NRC Responses to Public Comments on NUREG-0800, *Standard Review Plan*, Chapter 18, “Human Factors Engineering” and Related Documents

January 14, 2004

Figure 1. RAW vs. New Baseline CDF

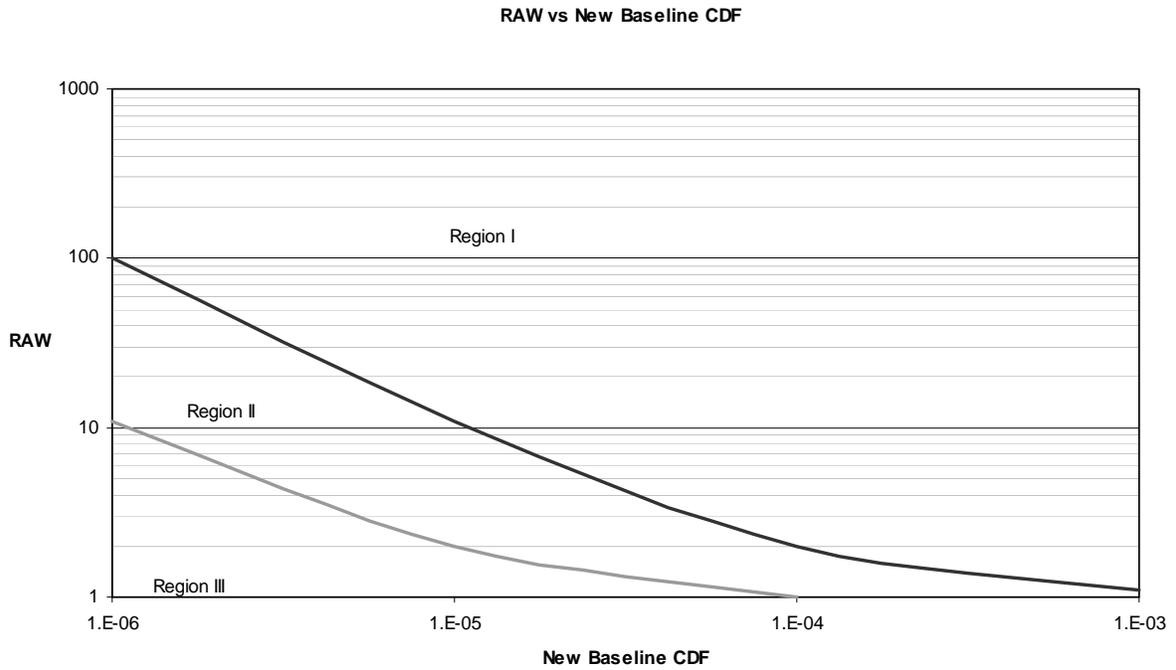
The bases for the FV and RAW criteria displayed in Figures 2.5, 2.6, 2.7 and 2.8 should be provided either by reference or by derivation in the document. It would also be desirable to

provide the mathematical equations plotted in these figures to facilitate implementation in software, for example.

Figures 2.5 and 2.6 show the Level assignments for RAW and FV analogous to the RG 1.174 Regions. The term Level was chosen to represent an amount of risk due to the HA and the corresponding amount of human factors engineering review. The levels are distinct and different from the RG 1.174 Regions. We note that these levels are not related to the three PSA Levels of CDF, source term releases from containment, and offsite consequences. RAW and FV values, which should be computed for the HA being evaluated, together with the new baseline CDF, will determine where on the Figures the HA is placed and which level of human factors review is assigned by Step 2. If an HA falls very close to the dividing line between two levels, then the reviewer may want to use the qualitative criteria in Step 3 to finally decide on the level of review for the HA (in Steps 3 & 4 of the screening process).

The curve delineating the split between the Level I and Level II areas of Figure 2.5 is roughly based on a CDF of $1 \text{ E-}4$ core damage events per reactor-year, the subsidiary objective of the Commission's safety- goal policy statement. Performance deficiencies associated with actions in the Level I area would generally be colored as Red in the new Reactor Oversight program. Similarly, the curve delineating the split between the Level II and Level III areas of Figure 2.5 are roughly based on a CDF of $1 \text{ E-}5$ core damage events per reactor-year. Performance deficiencies associated with actions in the Level II area would generally be colored as Yellow, those in the Level III area would be colored as White or Green. Figure 2.6 and the FV importance measure were added to have a second, different risk importance measure that would add robustness to the method. This measure addresses HAs that may not have a high RAW value (e.g., due to a relatively high base case HEP), but which contribute notably to the base- case CDF.

For the graph of RAW versus the new baseline CDF, after the modification is in place, the purple line separates Region 1 from Region 2. This is based on the Commission's safety goal policy (ref. 3) of not exceeding 1x E-4 core damage events per reactor year (for shorthand we will refer to this simply as E-4 in the rest of this document). We note that exceeding the E-4 value also corresponds to a Red finding in the new Significance Determination Process (SDP) as part of the new NRC Reactor Oversight Program (ref. 4). To explain, using the newly developed Risk-Informed Inspection Notebooks, inspection findings are evaluated by failing the item (or HA) in question and developing a color (red, yellow, white or green). The notebooks

Thus, we want to ensure with high confidence that the delta CDF remains less than E-4 for a modified HA. As a result we will define Region 1 to be that combination of RAW values and baseline CDF that equate to a delta CDF of E-4.

The purple line is a smoothed graph of the above data. The RAW criterion for any value of baseline CDF can be simply be calculated using the definition of RAW, in Equation 1 below.

Similar to RG 1.174 we will place this line one order of magnitude below the Region 1/Region 2 line. Using the terminology of above, this equates the lower portion of Region 2 to a delta CDF of E-5. Also Region 2 corresponds in risk importance to a Yellow finding in the new Significance Determination Process (SDP). Region 3 would correspond to a White or Green SDP finding.

For the Region 2/Region 3 line we use these values with the one exception that we drop the line to a RAW value of 1.0 at E-4 for conservatism. Thus any HA for at a plant with a revised baseline CDF greater than E-4 the HA would always be at least in Region 2.
